STATE OF NEW JERSEY
DEPARTMENT OF ENVIRONMENTAL PROTECTION

SUBJECT: L. E. Carpenter Facility Ground-Water Plans DATE: May 17, 1979

Well Location Plan

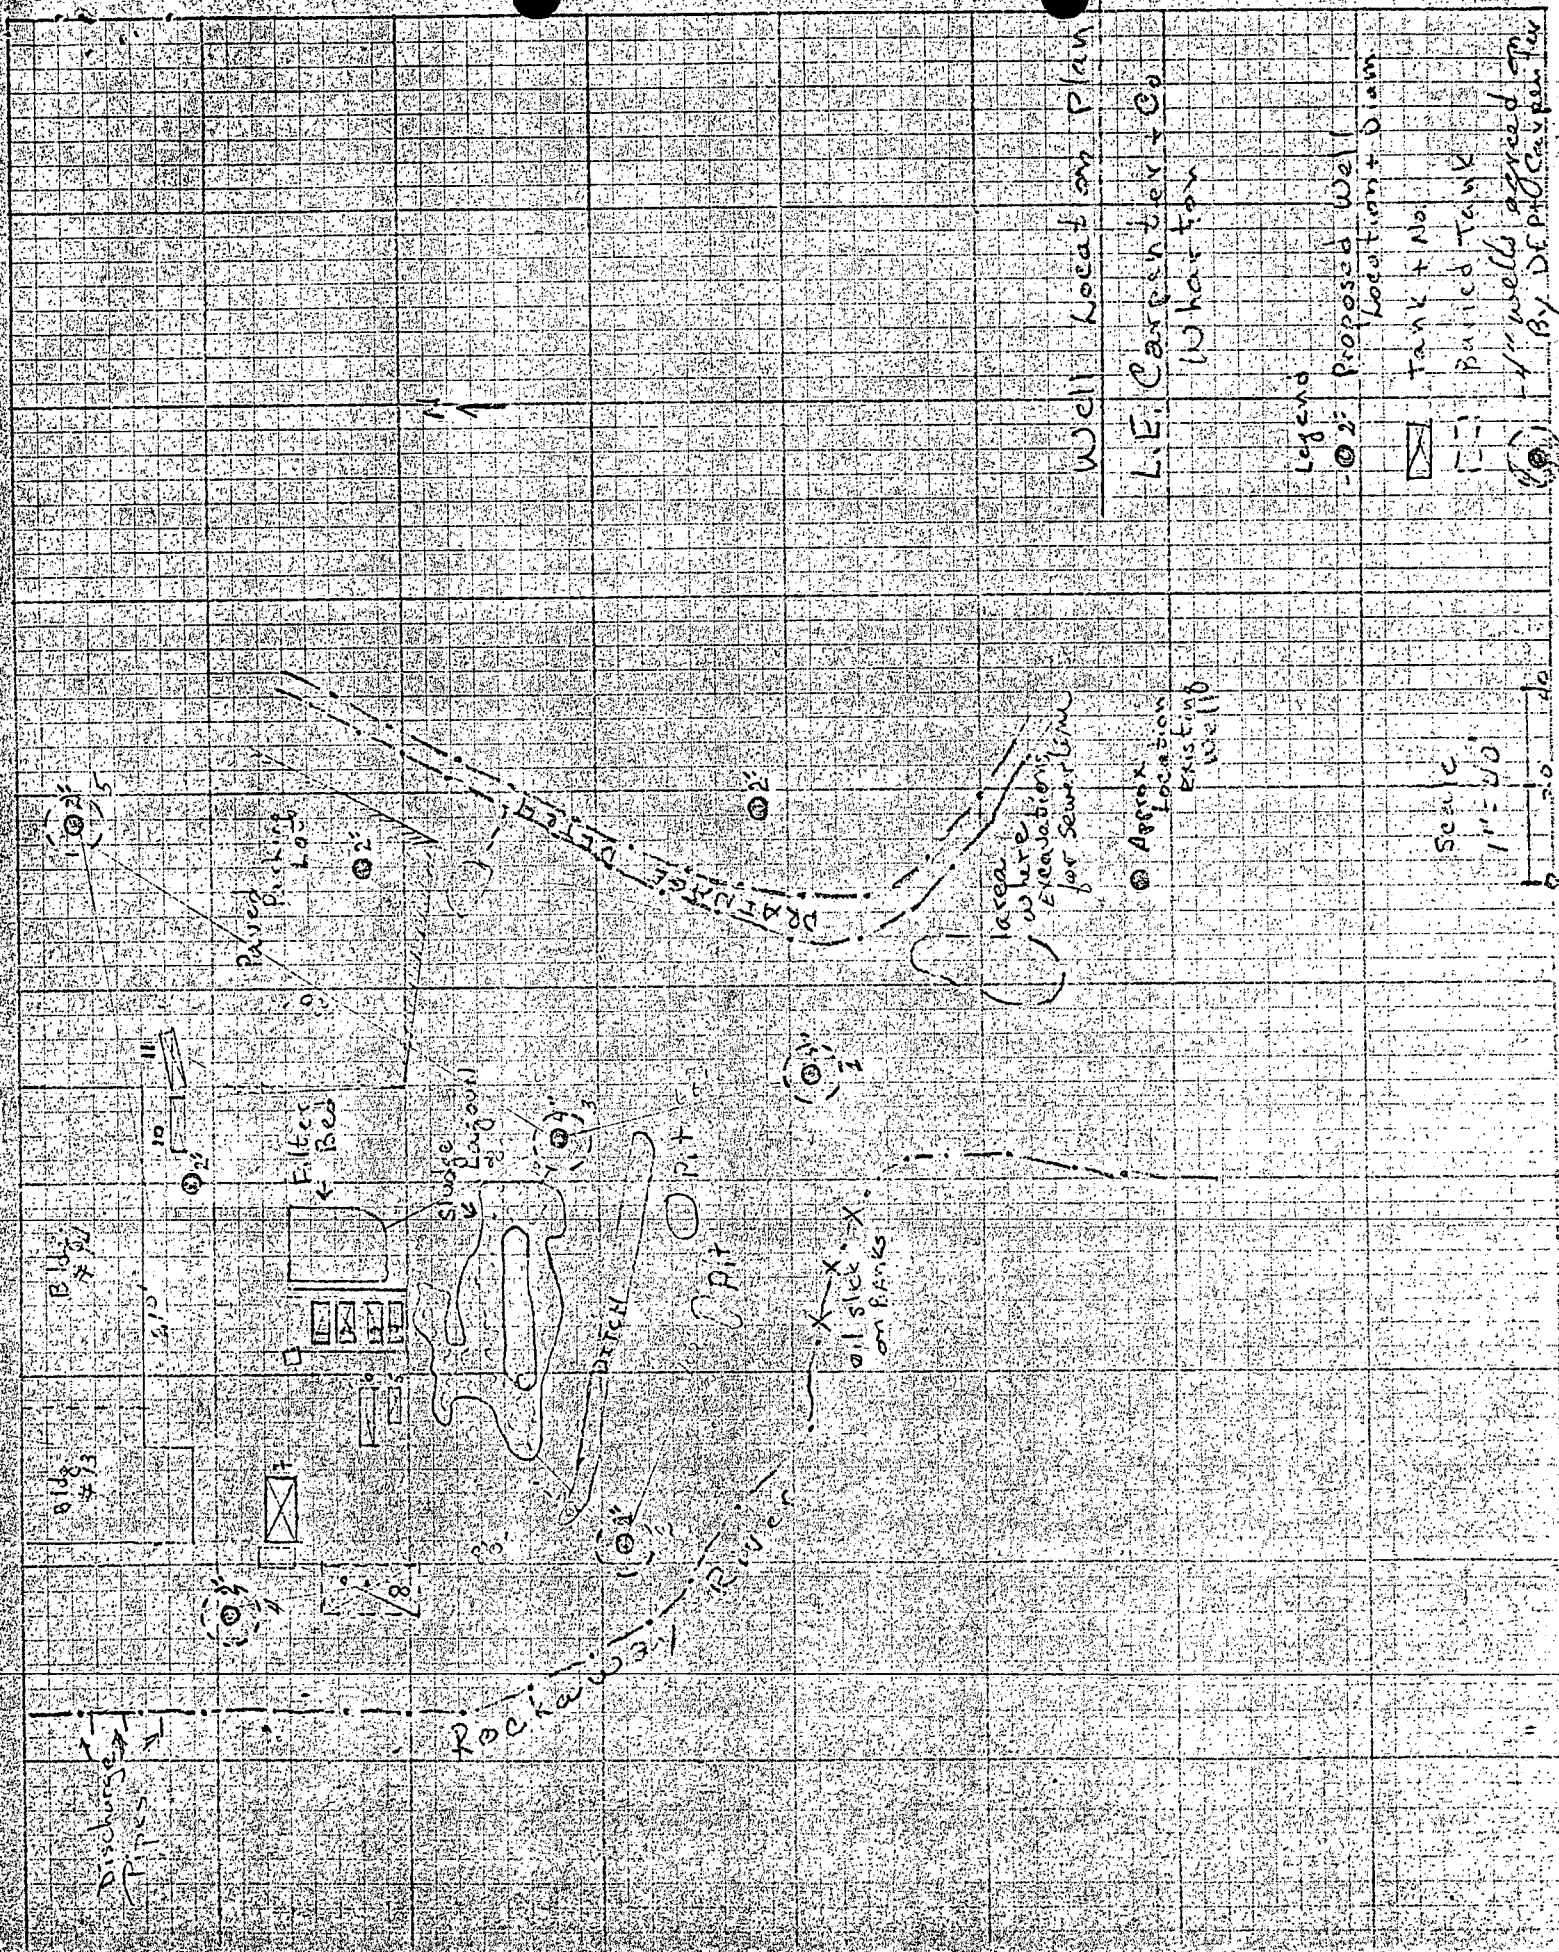
Initial ground-water investigation must begin with a series of monitor wells installed at locations throughout the facility to determine the movement of the ground water under the site. The exact locations of these wells will be determined on the site as drilling progresses in order to make the most effective use of each well. A tentative location map for these wells is indicated on the attached site plan. These wells should include at least:

- Five(5) two(2) inch PVC observation wells,
- Three(3) four(4) inch PVC observation wells which may later be used in the recovery system.

Of these eight (8) wells to be installed on the site, three (3) should be drilled to bed rock in order to determine the thickness of the saturated zone. Drilling to bed rock will be concluded if a substantial impervious zone (clay layer) is encountered. These wells will be terminated at the impervious boundary and screened at least ten (10) feet above the zone.

The other wells will be to various depths, based on field decisions, to determine whether there is a zonation of the pollution. The ground-water samples will be analysed for contamination by toxic substances.
